MONARCH GLEN SUBDIVISION

REVIEW COMMENTS

FILE #PP-2003-060

TITLE HEADING: Monarch Glen Subdivision

**PRELIMINARY
UTILITY COMPOSITE**

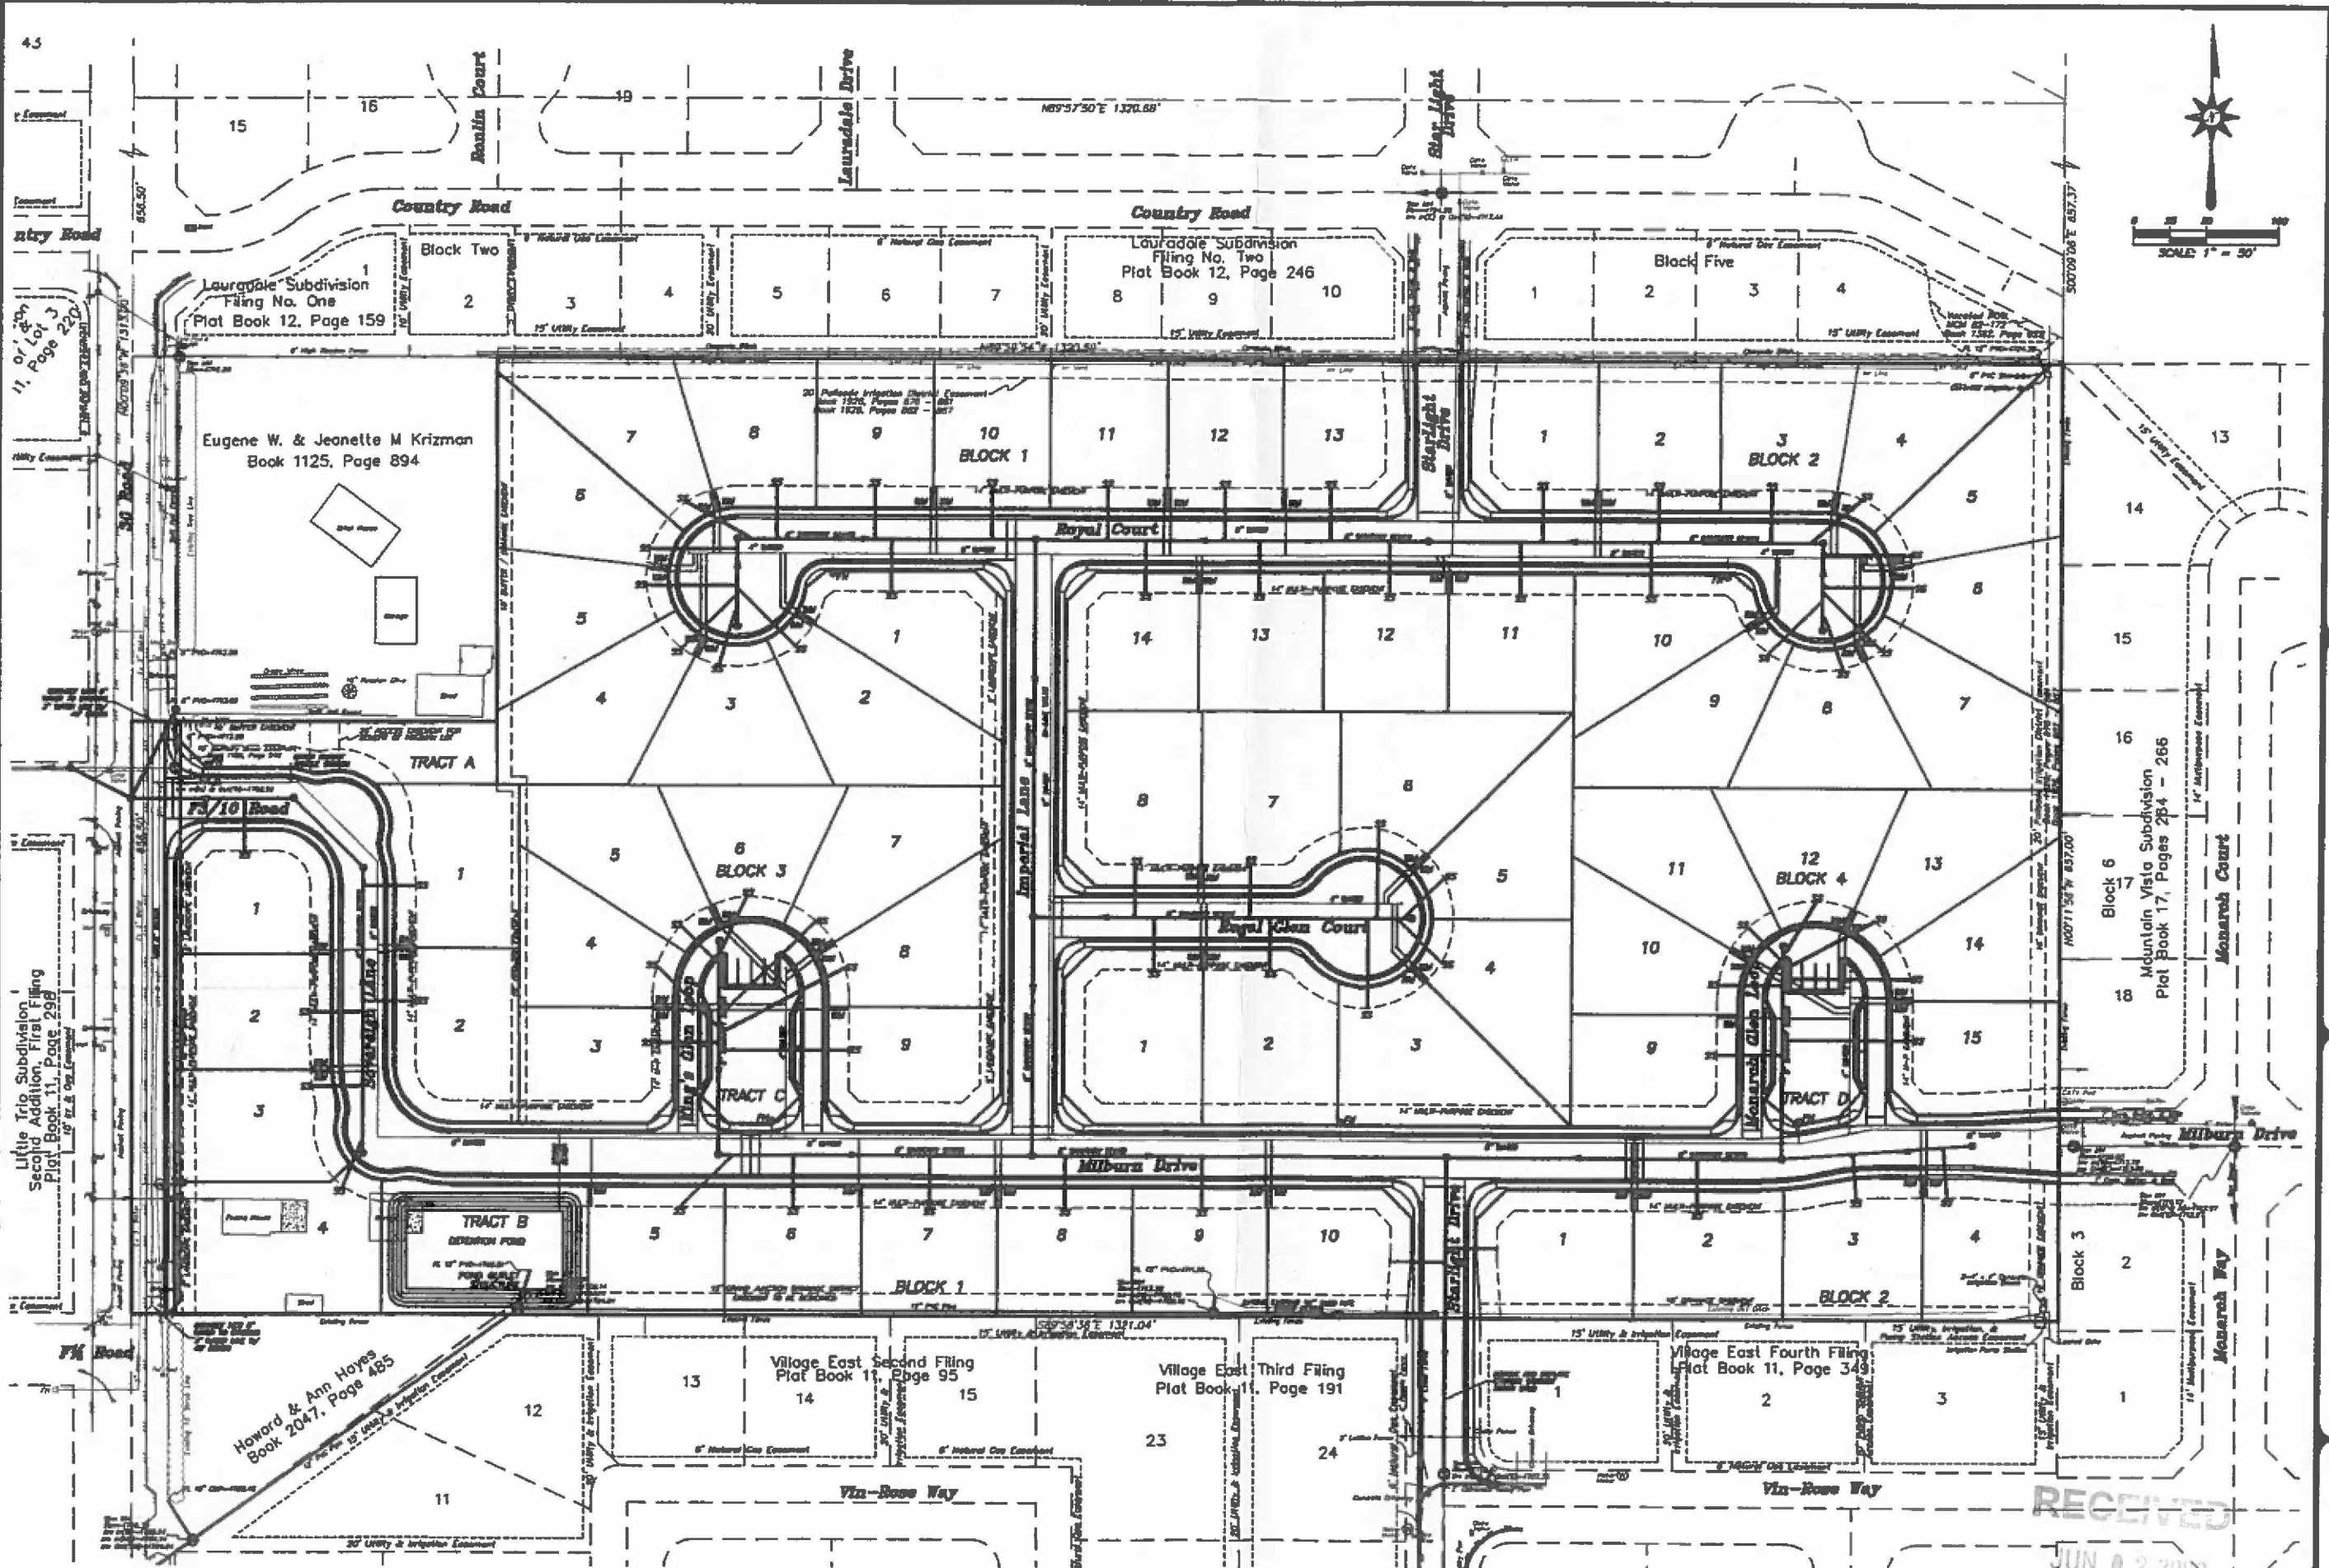
3 way valve south of Tract D (Monarch Glen Loop) needs one valve to the north

3 way valve south of Tract C (King's Glen Loop) needs one valve to the north

3 way valve at Imperial Lane and Regal Glen Court needs valve to north and east only

Add fire hydrant to SE corner of Imperial Land and Regal Glen Court

Eliminate in line valve at phase line, install bolted end cap, thrust block, and 1" blow off

Relocate existing water service tap for Lot 4, Block 1, to rear connecting to Milburn Drive main line.

1. The plans have been revised to show the existing 3-inch water line replaced with an 8-inch line along the frontage of the project. However, the petitioner will be contacting Clifton Water District to inquire if a fee can be paid to the district rather than constructing the water line.

2. The plans have been revised to show a water quality station within Tract A as requested.
3. The Loop Lane water lines have been revised to 4-inch and are located on the opposite side of the tract from the sewer line. In addition, the line termination is not located underneath pavement and the water meters are perpendicular to the water line where possible.

4. Comment acknowledged.
5. Comment acknowledged.
6. All 4-inch to 8-inch connections show a three-way valve assembly as requested.
7. Comment acknowledged.

Monarch Glen

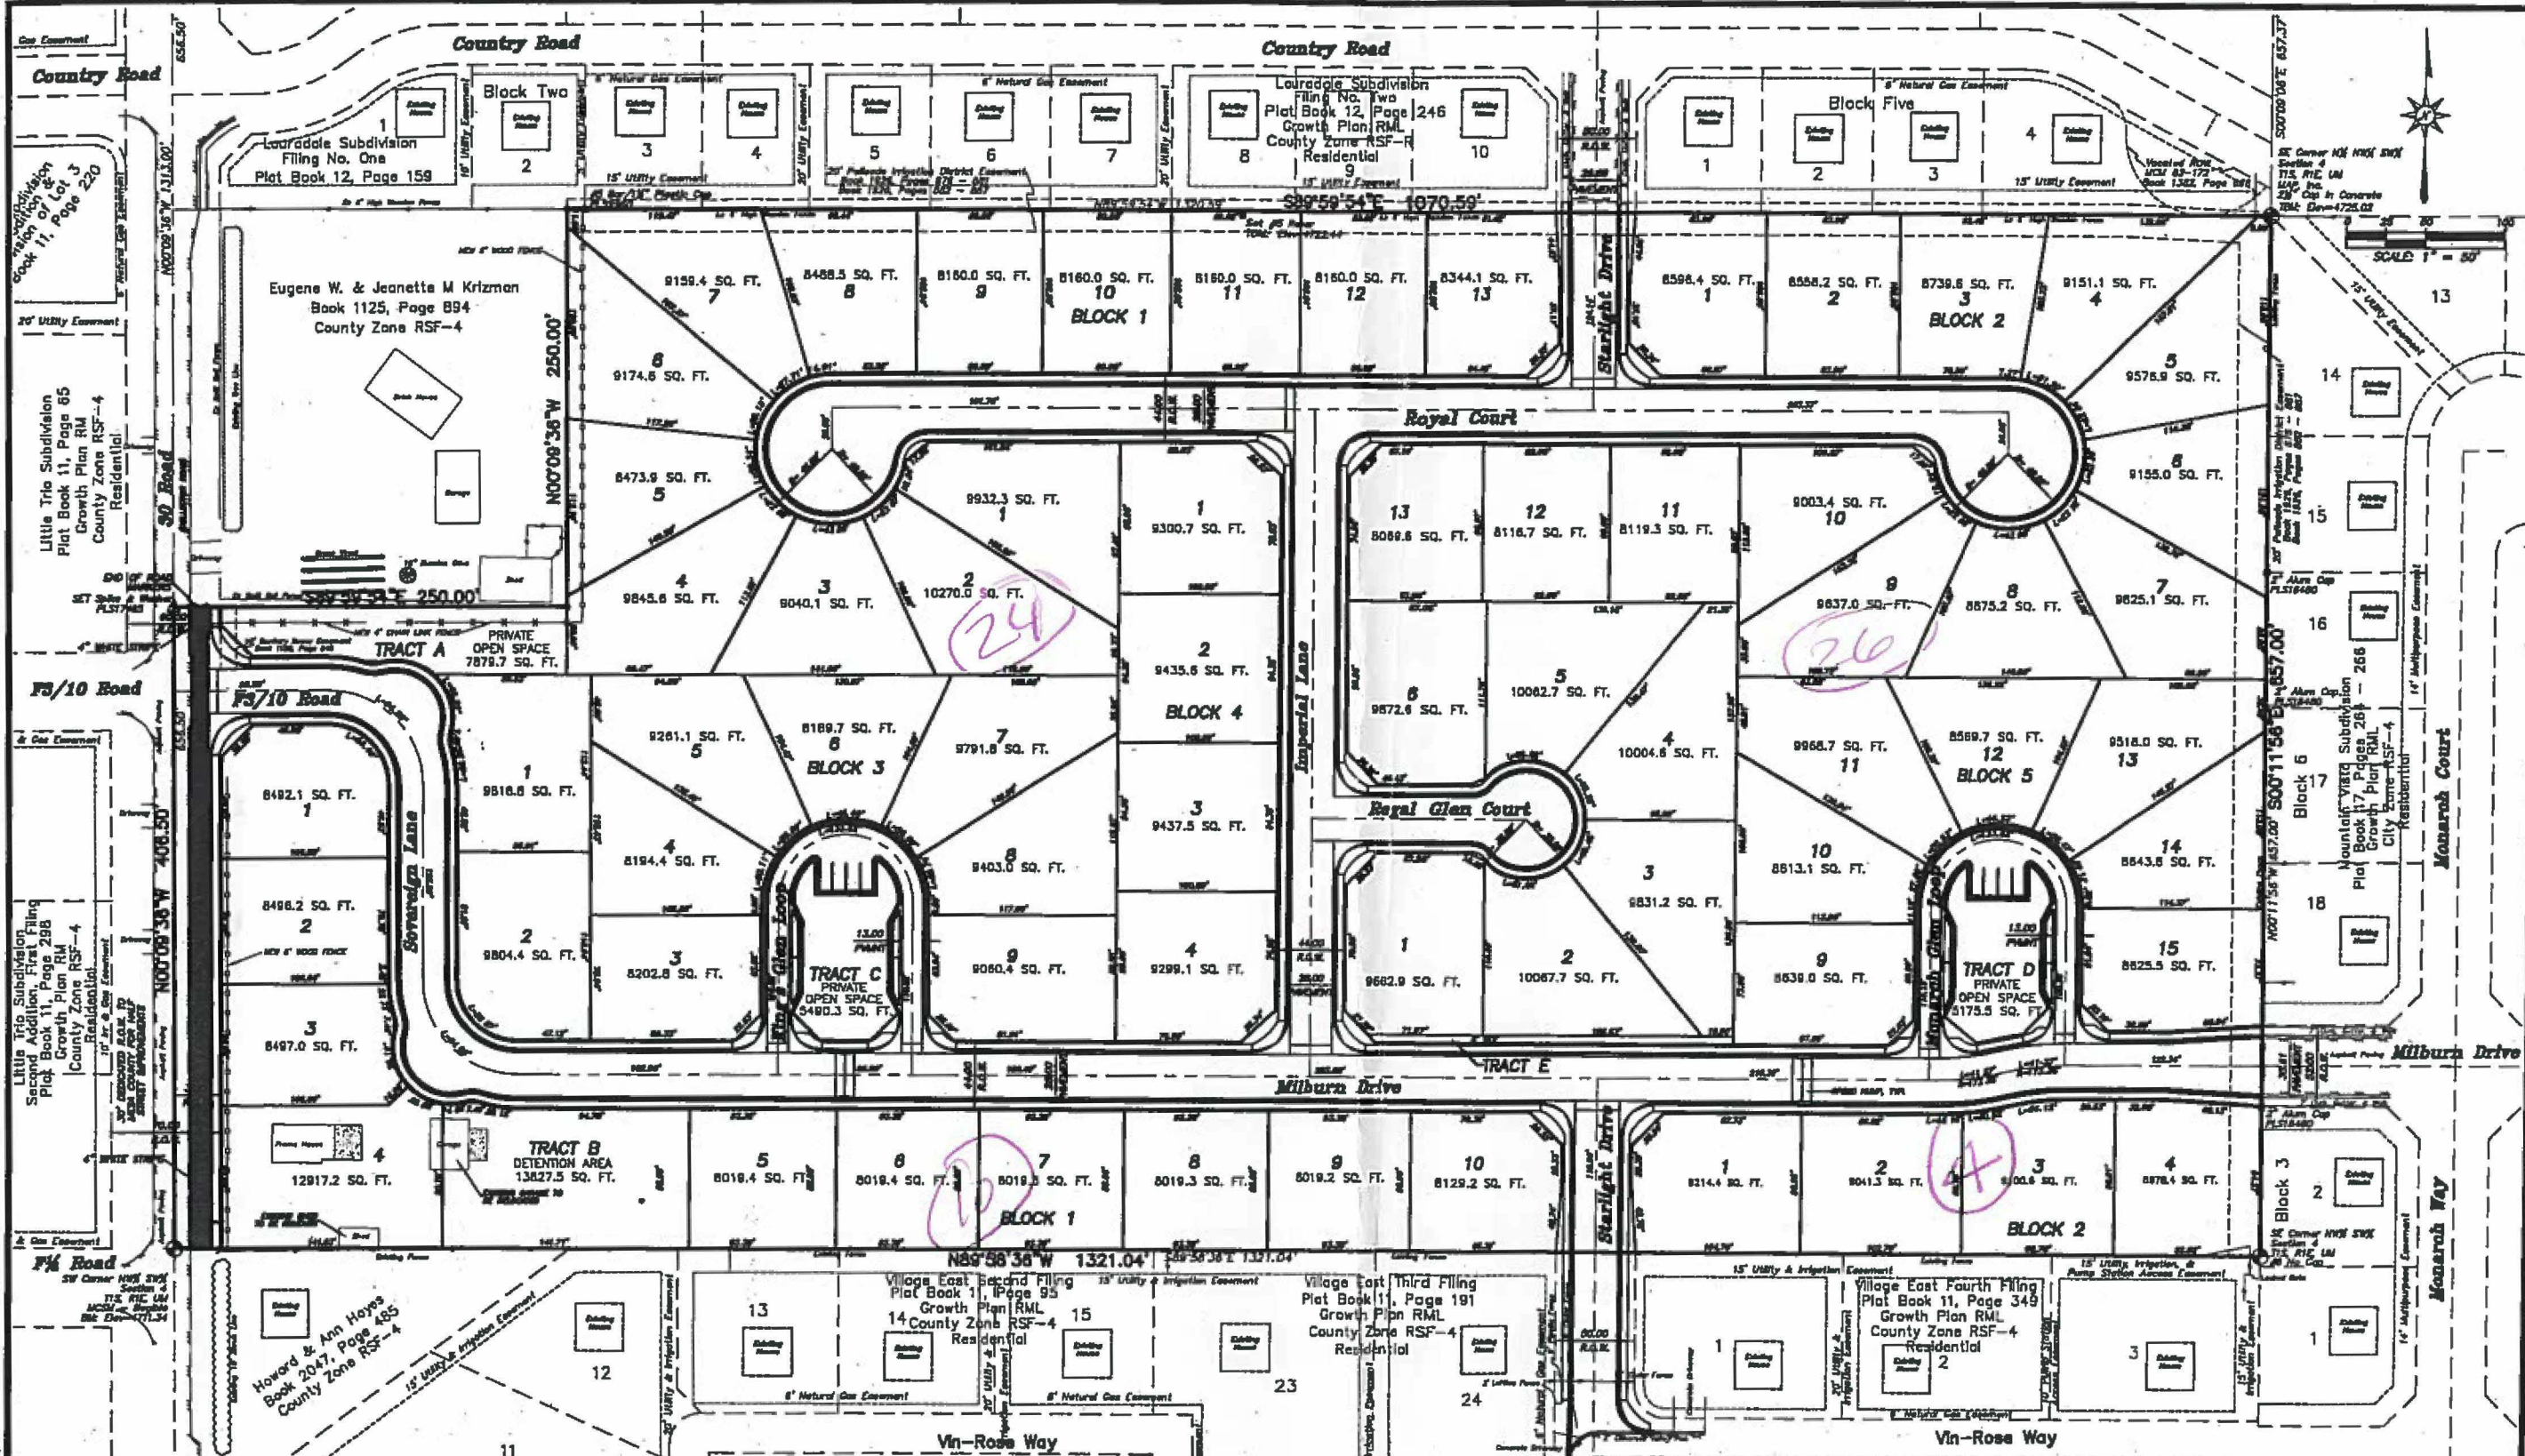
- Don't do south taper (Jarrell) property ^{not necessary}
- verify requirement for SB Lt Lane into sub
- Either work within existing ROW
or
